Work Order ID 127866

Item Name: Replacement Skidtube, High Gear with Standard Wearplates Fits LH or RH

DRAWING NO. D2650	TITLE 206/407 SKIDTUBE ASSEMBLIES	REV. F	DART AEROSPACE LTD ENGINEERING ORDER		D.E.O. NO. D2650-F-1	SHEET NO. SHEET 1 OF 1	SCALE NTS
DRAWN <i>[Signature]</i>	CHECKED A.P.	MFG. APPR. <i>[Signature]</i>	APPROVED <i>[Signature]</i>		DE APPR. <i>[Signature]</i>		
DATE 12.10.12	DATE 12.10.22	DATE 12.10.22	DATE 12.10.22		DATE 12.10.22

CHANGE C'BORED WELDED CROSSBOLT SPACERS TO SWAGED SPACERS

AMENDMENT TO DETAIL B
NOT TO SCALE

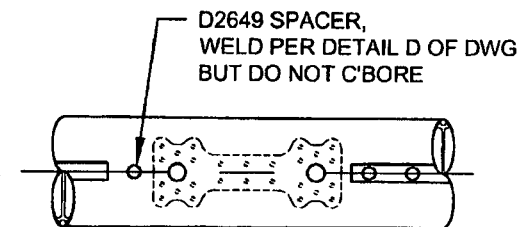
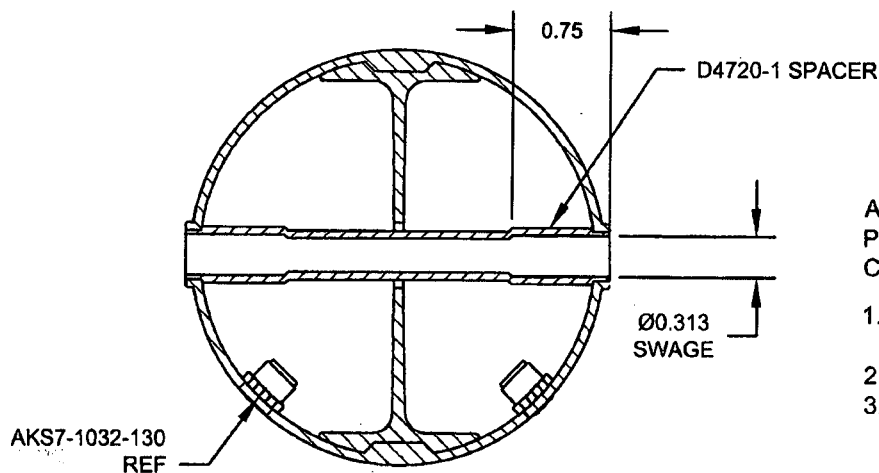
ADD DETAIL G BELOW, WHICH IS THE SAME SECTION VIEW AS DETAIL D OF DWG.

C'BORED HOLES ARE **NOW SWAGED** PER DETAIL G BELOW. FOR THE Ø0.375 HOLE THAT IS NOT C'BORED, WELD PER DETAIL D OF DWG (SEE AMENDED DETAIL B FOR REFERENCE).
